AMENDMENTS TO THE DRAWINGS

REMARKS

Title: SELF-CONTAINED ARTICULATED MATTRESS
Ser. No.:

Inventor: DAMEWOOD, K.
Attorney Docket No.: SMCY-P01-103

Fig. 6

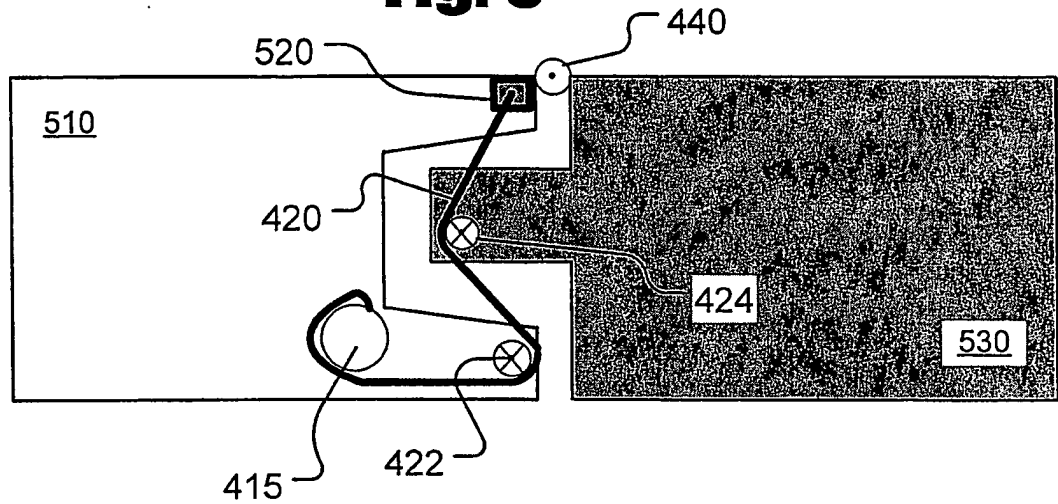
The attached replacement sheet 5/5 of drawings replaces original sheet 5/5 with Figs. 5 and 6, and includes changes to Fig. 6. The mattress is now shown as "640", the cover as "610", and the sleeping surface as "612." The specification has been amended accordingly.

The drawings are objected to for failing to comply with 37 CFR 1.84(p)(4) because the reference character "640" has been used to designate both cover and mattress in Fig. 6. This objection has been addressed by amending Fig. 6 and paragraph [0045] of the specification. Withdrawal of the objection is respectfully requested.
